Technical Service Bulletin: TSB110148

K19, K38 and K50 Rocker Housing Gasket Change

New Gasket, Part No. 3630839

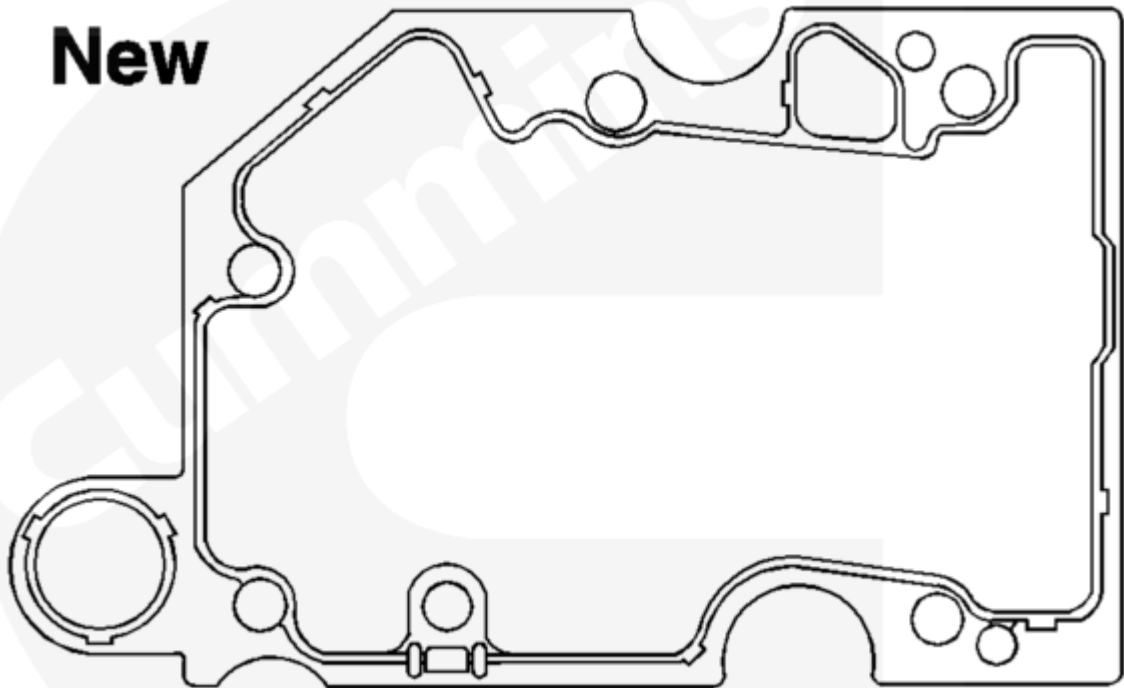
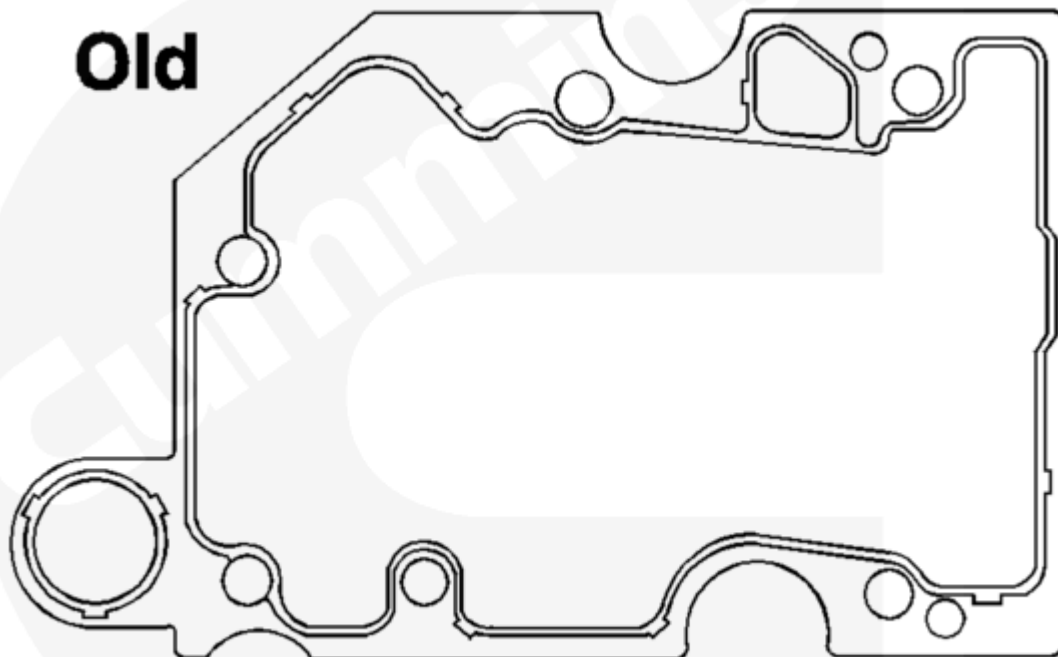
This document introduces a new rocker lever housing gasket for use on all current and past K19, K38, and K50 engines. The new gasket, Part No.

3630839 **replaces** Part No. 3628330.

The new gasket is edge-molded and based on a modified version of the original edge-molded rocker lever housing gasket. The profile of the gasket was altered, but the material of the gasket remains the same. It is designed to fit **both** current production engines and older engines built with non-STC rocker lever housings. The old gasket, Part No. 3628330 released on 24Oct1994 did not seal the older non-STC engines.

The new gasket went into production in the third quarter of 1996 for all K19, K38, and K50 engines.

Note : All gasket sets packaged after 24Jul1996 will have gasket Part No. 3630839 in them.
